RE: 14508 Sierra Ct. NE 14508 Sierra Ct. NE Grading and Drainage Plan Engineer's Stamp Date: 02/01/2022 (check this) Hydrology File: L23D037

Based upon the information provided in your submittal received 01/31/2022, the Grading & Drainage Plan **is not** approved for Building Permit. The following comments need to be addressed for approval of the above referenced project:

## SHEET C1

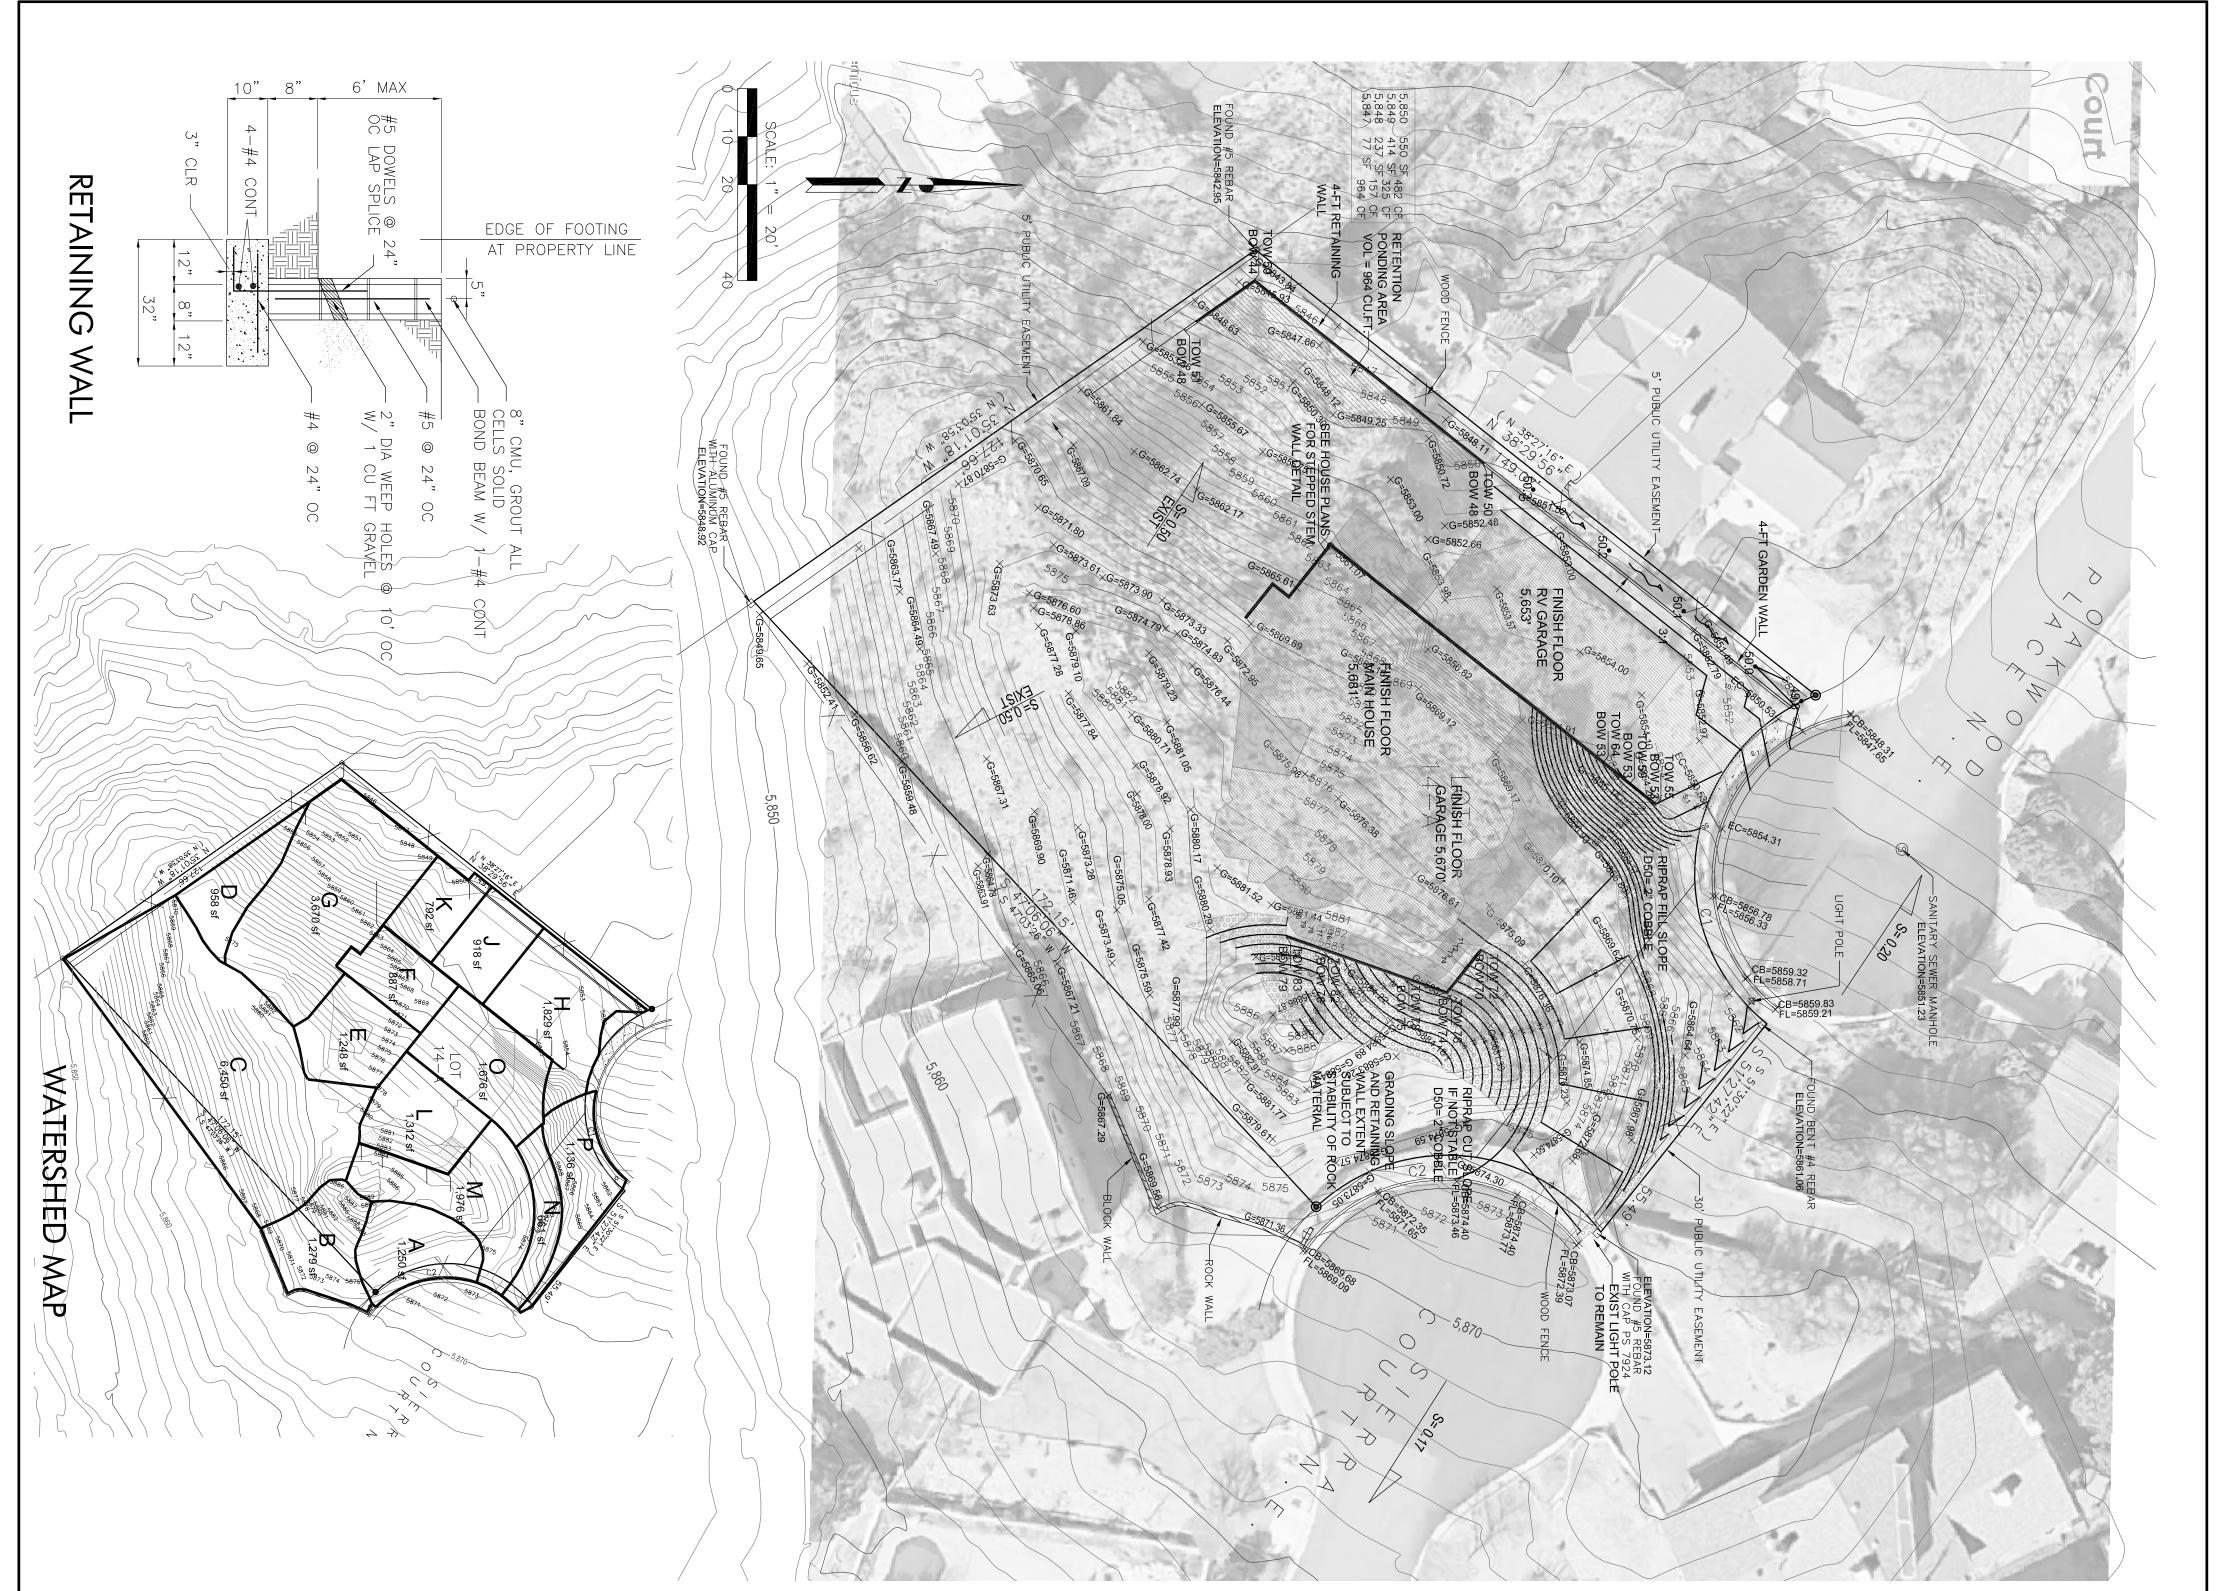
- Review the grade at the back of the home. It appears a stem wall will be needed there as well as there is a 10 ft grade difference. Please ensure there is a detail for these stem walls appropriately.
  - a. Review any other grading issues where a retaining/stem wall may be needed.
- 2. Prior to approving this, we will need written approval and allowance for the work being completed on adjacent property.

3. If there is drainage crossing the lots, a cross lot drainage easement will be required (platting?)

- 4. Discussion with Shahab, he mentioned it seems unlikely that basin C will be undisturbed. If any disturbance to that area, you will need to provide a pond.
  - a. It would benefit the project to simply place another pond to avoid having to not touch that area. Simply driving over, it with backhoe etc... could cause enough disturbance when we go out there to seem like it is disturbed and may result in denying a CO.
- 5. Remove the aerial photo in the background. It clutters up the linework/design.
- 6. Provide a detail of the overflow and how it will discharge into the proposed swale to the roadway.
  - a. This needs to be clearly shown with a cross section.
- 7. Please note that the approved G & D must be followed and not doing so will result in the site not receiving a CO.
